TOLERANCES (EXCEPT AS NOTED)		BUCHLA ASSOCIATES	
DECIMAL	series 200	SCALE	DRAWN BY D.B.
±		—	APPROVED BY
FRACTIONAL	TITLE	PART OF QUAD SANDH MOD. 264	
±	SCH: POLYPHONIC ADAPTOR		
ANGULAR	DATE	DRAWING NUMBER	
±	12-3-70	B 2640-2

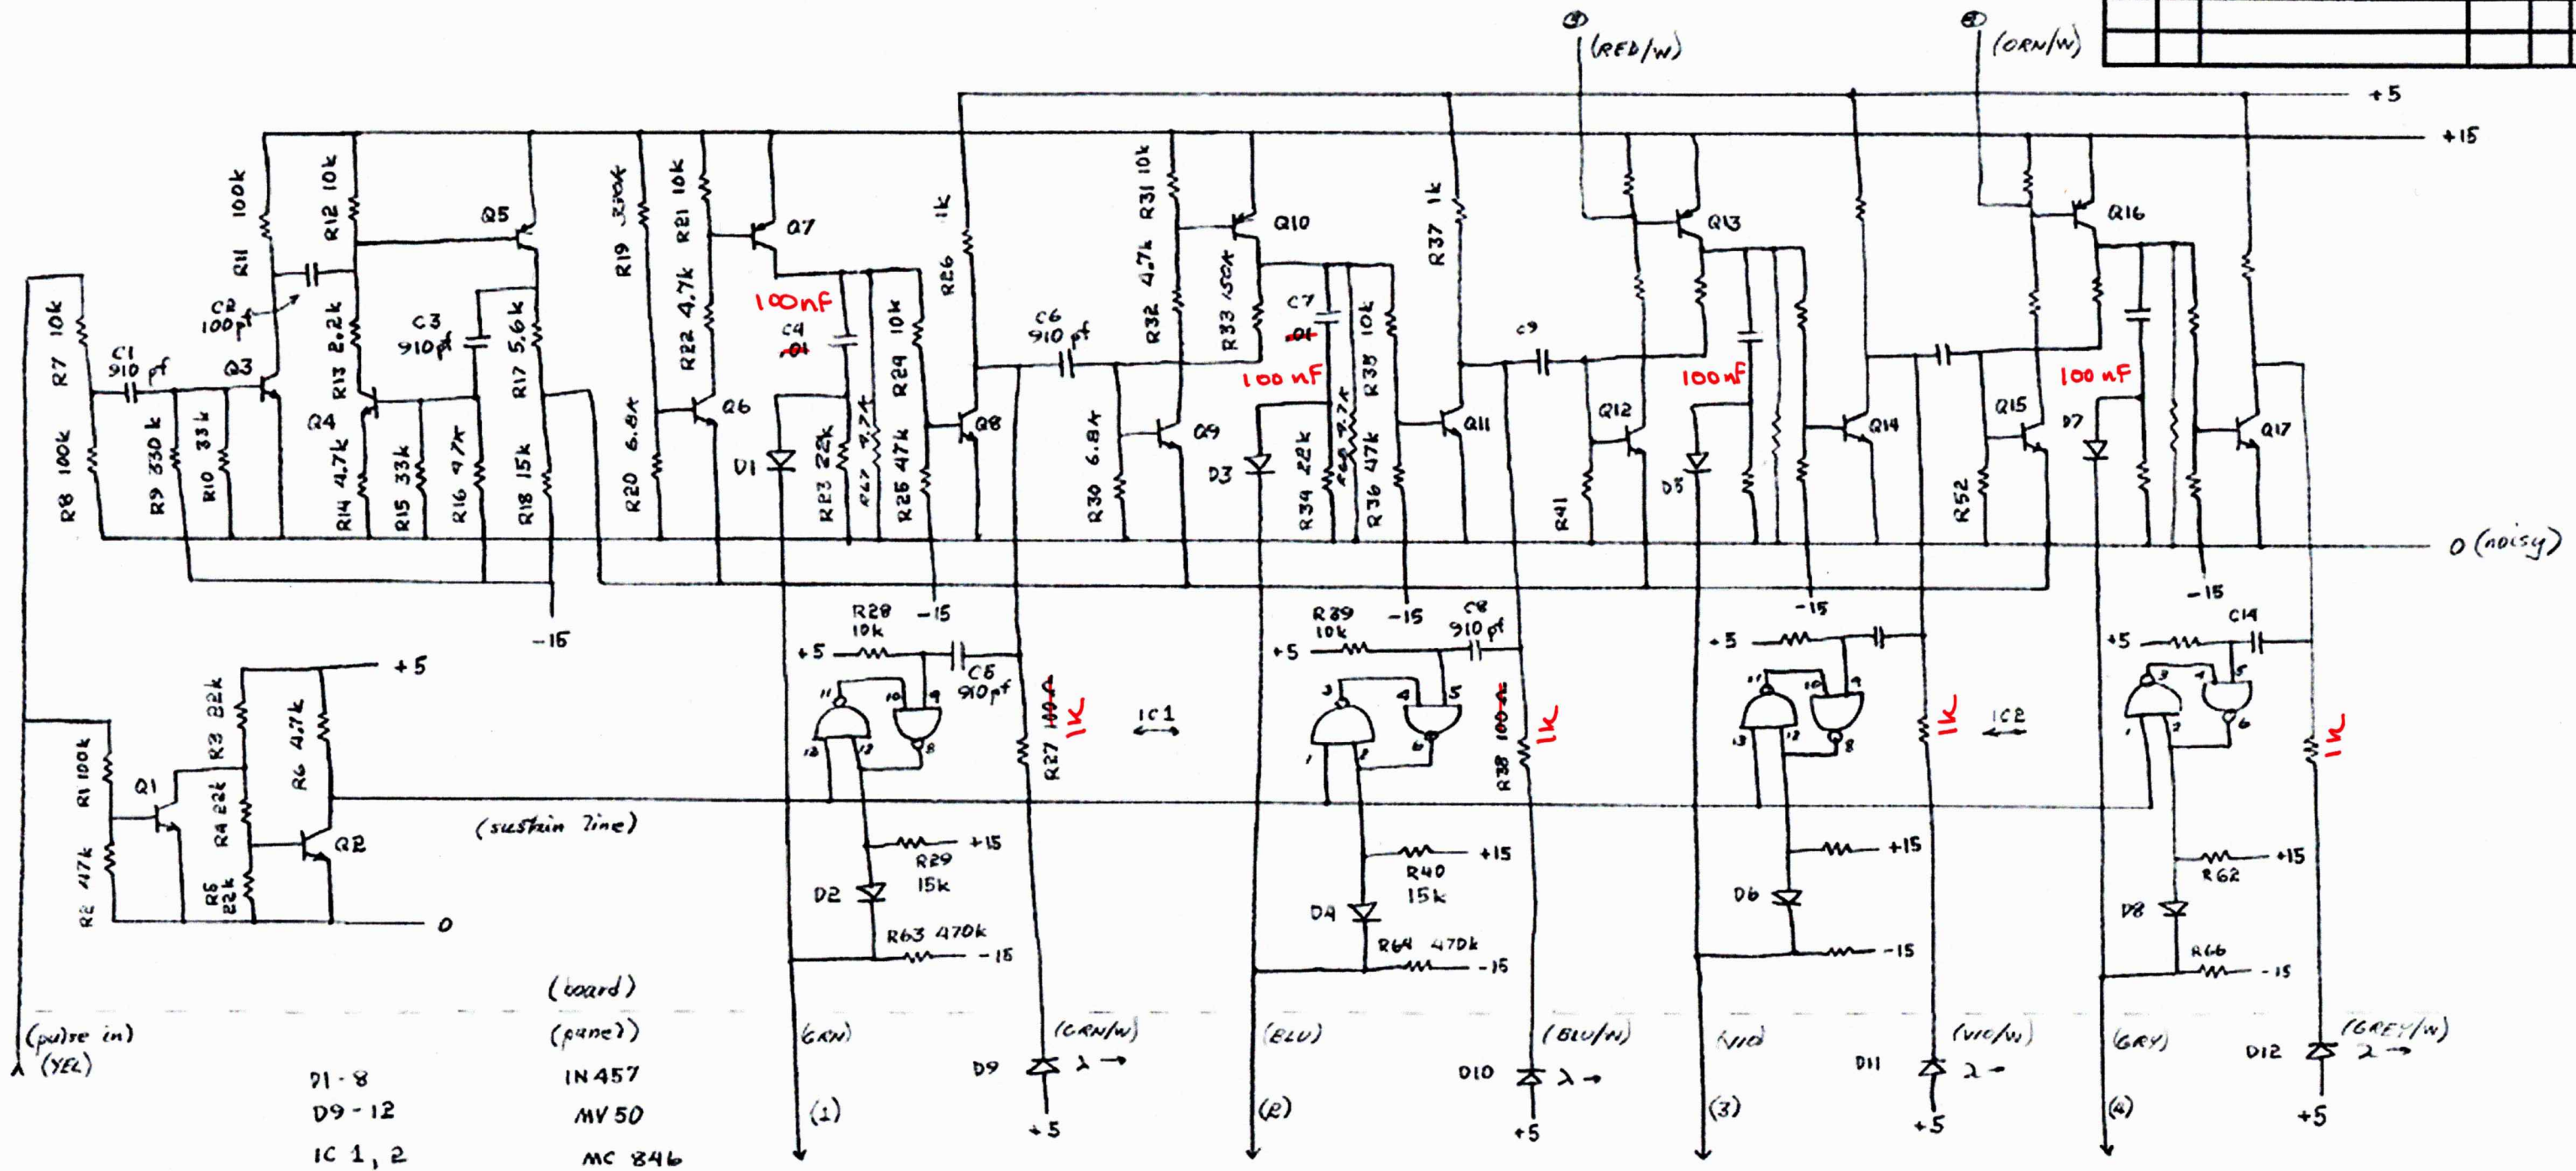
DATE	BYM	REVISION RECORD	AUTH.	DR.	CK.
1/71		CHANGE R16, 17, R21, 23, R2, 33, 34 ETC. ADD R67-70

(if more sust. drive needed,
change R29, etc to 5.6k
and sub MC 849 for 846)

Done B
8-27-71
